Amendments to the Central Waterfront

就規劃申請 編號:Y/H24/4 提出意見 Comments on Planning Application No.: Y/H24/4

Changes proposed to the Central District Outline Zoning Plan 就中區分區計劃大綱圖提出的修訂及意見

Changes to Central District (Extension) OZP 就中區(擴展部分)分區計劃大綱圖提出的修訂及意見

The site between IFC and the Ferry Piers

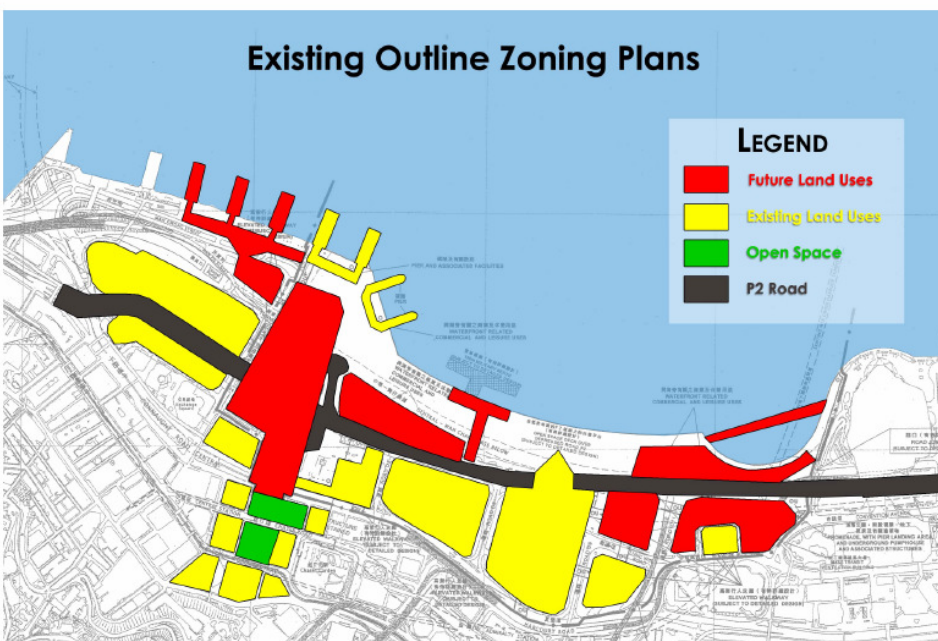
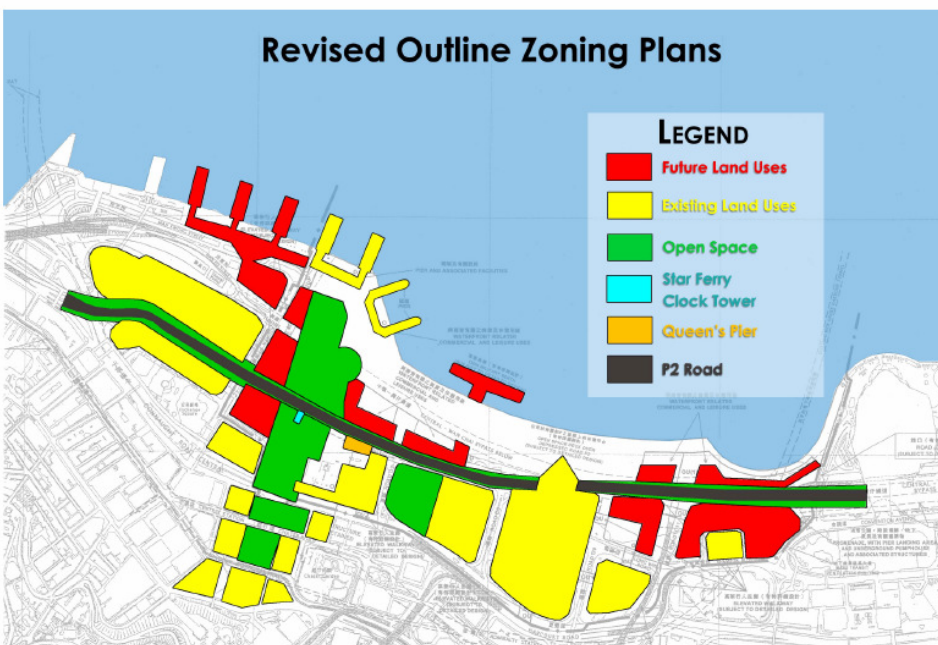
- The site "C" be included in the "CDA(2)" zone; 把「商業」地帶包含於「綜合發展區(2)」地帶內；
- Height limit for CDA(2) of 50mPD and 22mPD for Piers 4, 5 and 6; 「綜合發展區(2)」的高度限度設定為「主水平基準上50米」及「四號、五號及六號碼頭」的高度限度設定為「主水平基準上22米」；
- To exclude "Public Transport Interchange"; 刪除「公共交通交匯處」；
- The "G/IC" site to the west of the CDA(2) site be restricted to a height of 50mPD. 將「綜合發展區(2)」地帶以西的「政府、機構或社區」地帶設定高度限度為「主水平基準上50米」。

8. Transport: A Tram 交通運輸：電車

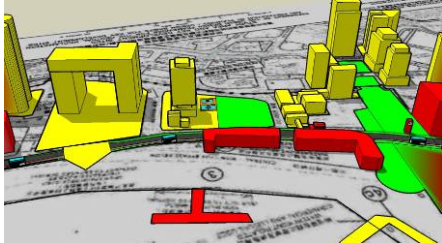
It is proposed that the Notes for the "Open Space" and other relevant zones be amended to permit the development of a tram system. Alternatively the actual alignment and proposals for a tram system or other environmentally friendly transport system be shown on the Outline Zoning Plan. 建議修訂「休憩用地」及其他有關地帶的「註釋」，加入有關提供「電車路線」的規定。或在大綱圖上顯示確定 / 建議的電車路線或其他環保交通工具設施。
